Tempest and Trophy Propeller Flo-Torq II Bushing (A45/A46 Series)

NOTICE

Revised August 1998. Destroy original February 1998 Bulletin. Changes are underlined.

- a** - Bushing
- b** - 55 lb. ft. (75 N·m)

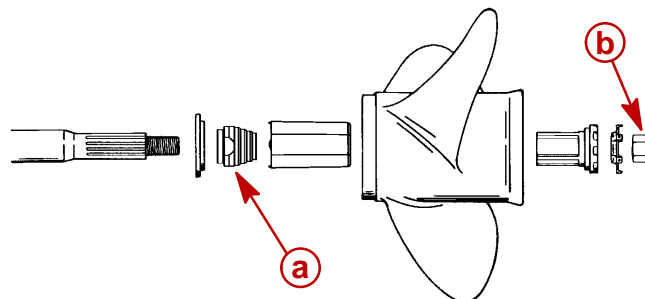
Under certain applications a Tempest or Trophy A45/A46 Series propeller may experience a loosening condition. If you encounter this problem, it is recommended that the propeller be removed and a Flo-Torq II Bushing be installed. This bushing will eliminate any propeller nut loosening.

Propeller nut loosening will cause the forward thrust hub to fret and wear on the thrust hub's taper. Continuous wear on the taper will allow the propeller to move forward and contact the gearhousing and/or the carrier retainer nut.

During installation of the Flo-Torq II Bushing, the forward thrust hub and the drive sleeve should be inspected for any signs of wear. Replacement of any worn parts is recommended. Torque the propeller nut to 55 lb. ft. (75 N·m).
